05 April 2023

AEMO Victorian Planning (AVP) and Transgrid

RE: VNI West Consultation Report – Options Assessment (February 2023)
Non-confidential submission

Figure 2 - Gippsland REZ - Step Change outcomes

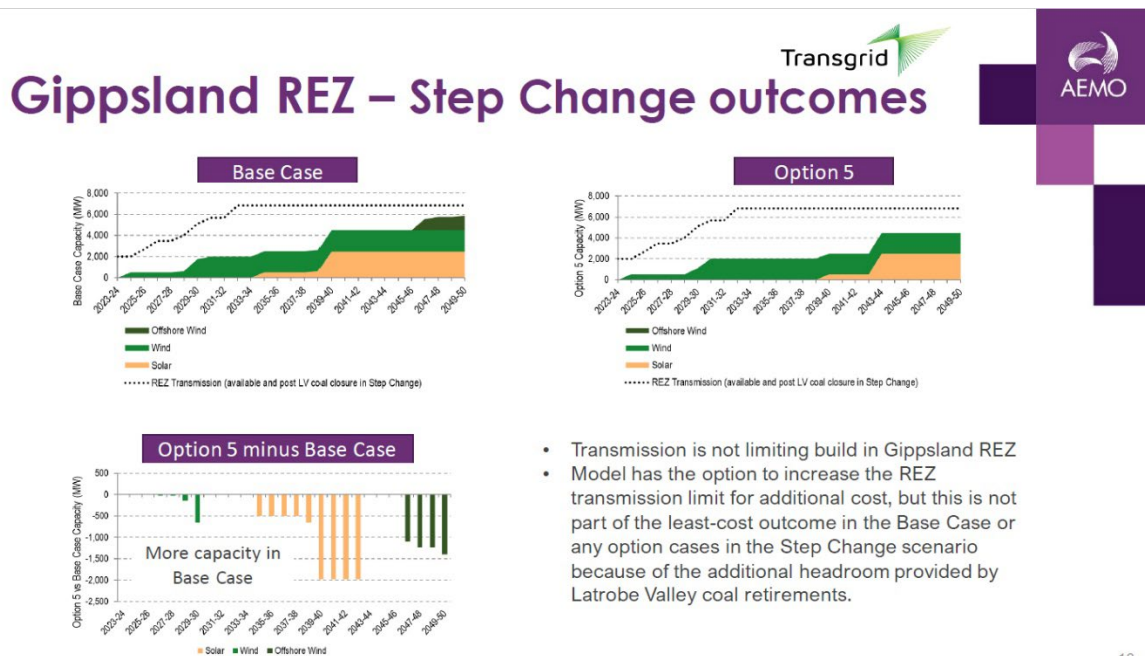
EGA is concerned that excluding Gippsland is the wrong choice for Victoria and the 2,000 MW build limit, based on land use constraints, has no meaningful foundation. There are great opportunities in Gippsland, with its strong transmission network.

The delayed timing of Gippsland investment, as a result of VNI West Option 5, does not align with the Victorian Governments objectives and does not align with local government objectives in the Latrobe Valley.

With VNI West Option 5:

- Offshore wind is not developed off the Gippsland coast. This is despite the Victorian Governments clear commitment to offshore wind.
- Onshore wind is not developed in Gippsland, beyond the 2,000 MW hard build limit, until 2043-44, and in the base case until around 2039-40.
- Solar developments experiences similar constraints.

Figure 3 – Gippsland REZ - Step Change, offshore wind sensitivity outcomes

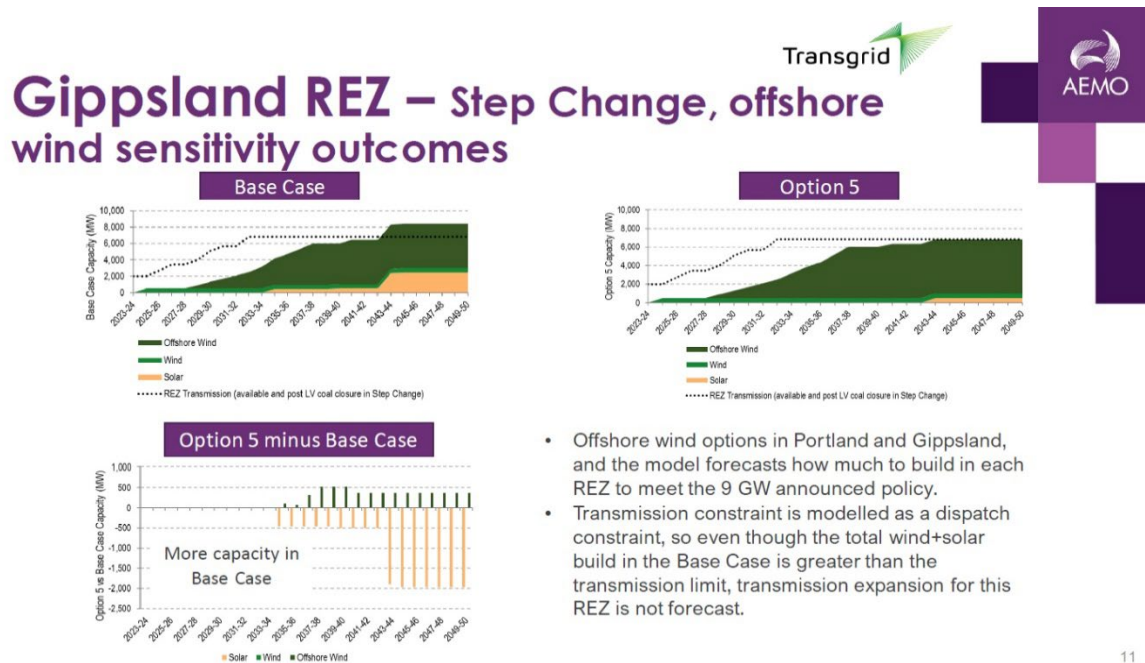
Step Change Scenario with the offshore wind sensitivity applied:
